COUNCIL ASSESSMENT REPORT

SYDNEY EASTERN CITY PLANNING PANEL

PANEL REFERENCE & DA NUMBER	PPSEC-321 – DA-2024/133
PROPOSAL	Demolition of existing structures and construction of an eight (8) storey mixed use development comprising of ground floor retail and parking, seven (7) levels of residential units, basement and above ground car parking and landscaping
ADDRESS	573 Gardeners Road, Mascot Lot 1 in DP 334819, Lot 1 in DP 335231
APPLICANT	Mecone
OWNER	APKC Pty Ltd
DA LODGEMENT DATE	14 June 2024
APPLICATION TYPE	Integrated Development
REGIONALLY SIGNIFICANT CRITERIA	Section 3.10, Schedule 6 of <i>State Environmental Planning Policy (Planning Systems) 2021</i> : Private infrastructure and community facilities over \$30 million
CIV	\$62,701,806 (excluding GST)
CLAUSE 4.6 REQUESTS	Bayside LEP 2021, Section 4.3 – Height of Building
KEY SEPP/LEP	<ul style="list-style-type: none"> • State Environmental Planning Policy (Planning Systems) 2021 • State Environmental Planning Policy (Biodiversity and Conservation) 2021 • State Environmental Planning Policy (Resilience and Hazards) 2021 • State Environmental Planning Policy (Transport and Infrastructure) 2021 • State Environmental Planning Po

Figure 11: Entry sequence mark up (supplied by the applicant)

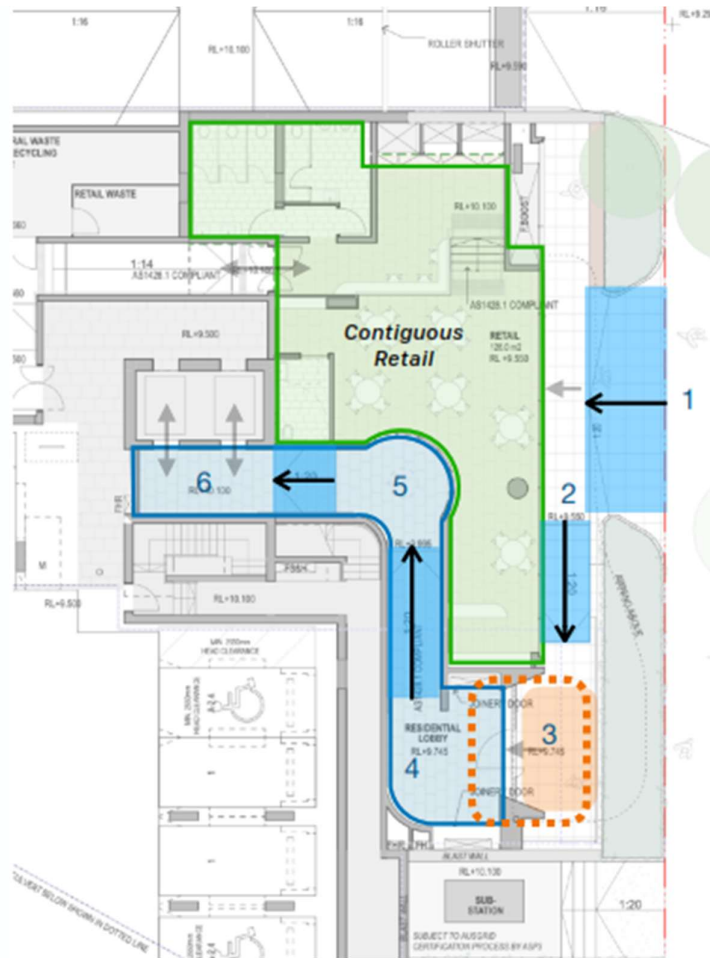
- (b) *The entry sequence from Gardeners Road to the residential lobby is to be simplified, as it is currently a long and rather contorted route to access the lifts*

Applicant response: *The residential lifts must be flood protected, and therefore must be elevated 700mm from the Gardeners Road footpath to achieve this protection. The proposed design implements 1:20 walkways to traverse this elevational change, which is a comfortable gradient. Any steeper (eg 1:14 ramp) and handrails, kick rails and tactile indicators are all required, which, are commercial in character and detract from what should be an overtly residential setting. 700mm of elevation at 1:20 gradient equates to 14m of walkway ramping. Gardeners Road experiences heavy vehicular traffic. The optimal design for these frontages are protected and nurtured spaces with introverted, intimate experiences. The following figure shows a more detailed design, split up into six different portions (detailed further below):*

1. *Relative level access from the sidewalk via the landscaped setback reserve. A gentle 1:20 walkway is embedded within the landscape and 'folds' up to arrive within the portal and in a level landing area outside the retail glazing.*

2. *The portal edge then frames the second 1:20 walkway, invisible from the street.*
3. *The walkway comes to a sheltered, elevated arrival 'moment', with setback glazing creating a more generous space for residents and heavier planting to shield it from vehicle traffic.*

Figure 12: Building separation to neighbouring developed sites (supplied by the applicant)

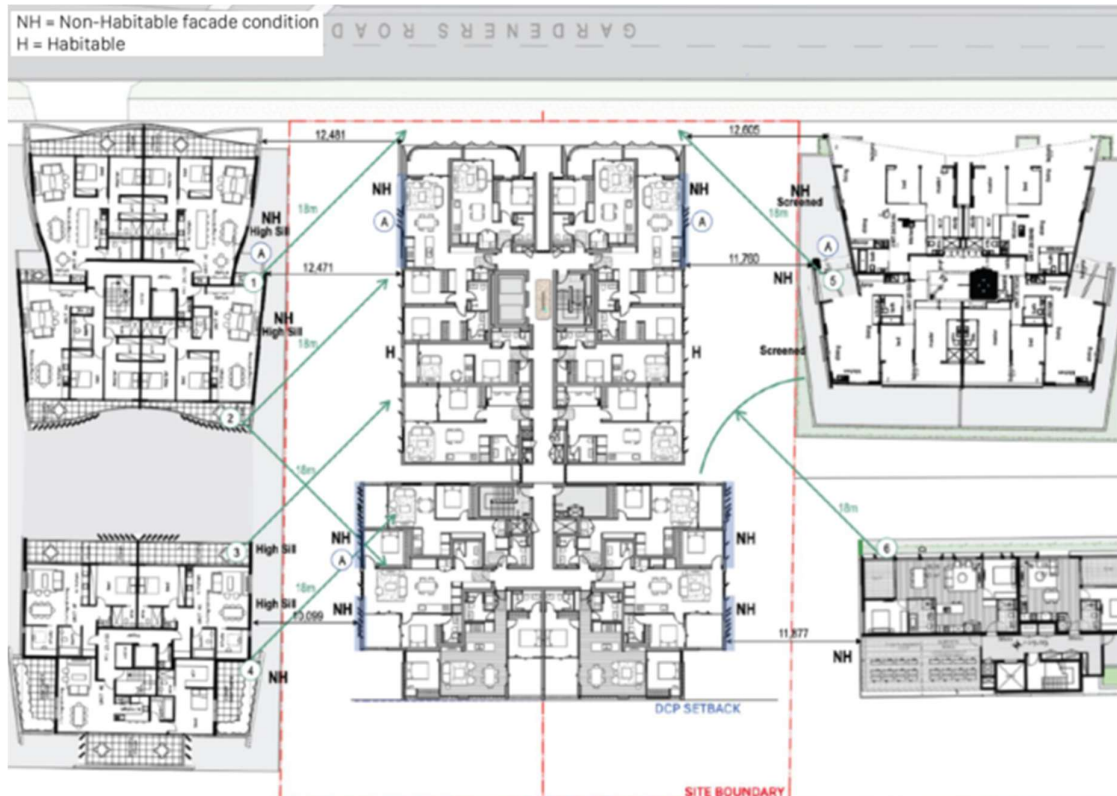
Minimum building separation is difficult to achieve given adjacent developments are in close proximity to the boundary and do not comply with ADG separation.

As shown in the Figure above, building separation and visual privacy distances are achieved to the north and south in accordance with the ADG. However, recent existing residential apartment developments to the east and west (common side boundaries), with setbacks as low as 2m, do not provide for equitable sharing of building separation distances, and therefore total separation distances cannot be strictly achieved to these boundaries.

Objective 3F-1 of the ADG design criteria prescribes to “achieve reasonable levels of external and internal visual privacy”. As shown in the above Figure, the adjoining developments generally provide for blank walls or high sill windows facing the proposed development. The proposal has been designed in response to this, with direct views to opposing blank walls or non-habitable facades, whilst providing angled blades and façade articulation to provide privacy screening and angled views out from the façade line which break up direct lines of sight between habitable rooms within the buildings. Where possible, primary views for living areas (which are more frequented than bedrooms) are oriented to the north and south where building separation distances are achieved. Notwithstanding the numerical departure, it is deemed that the proposal satisfies Objective 3F-1 of the ADG by

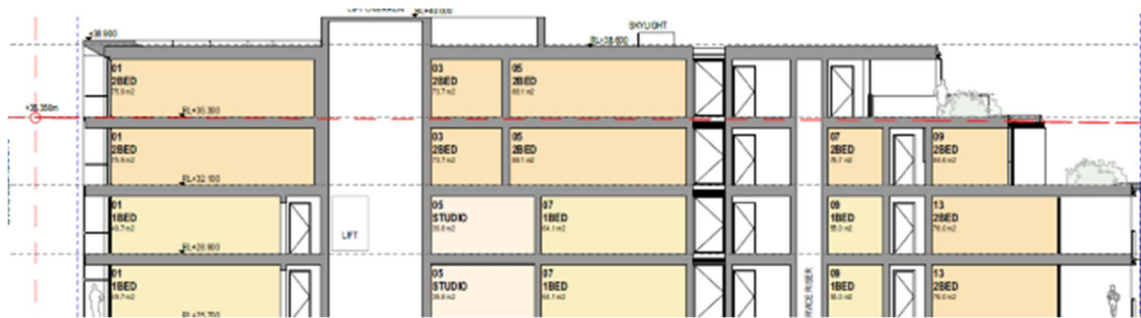
The proposed development has a maximum height of 30.65 metres (RL 40 AHD) which does not comply with the provisions of this Section. This is a height exceedance of 4.65 metres to the top of the lift overrun and results in a variation of 17.9%.

As shown in the section below, this represents one part residential level, communal open space, as well as the lift over run.
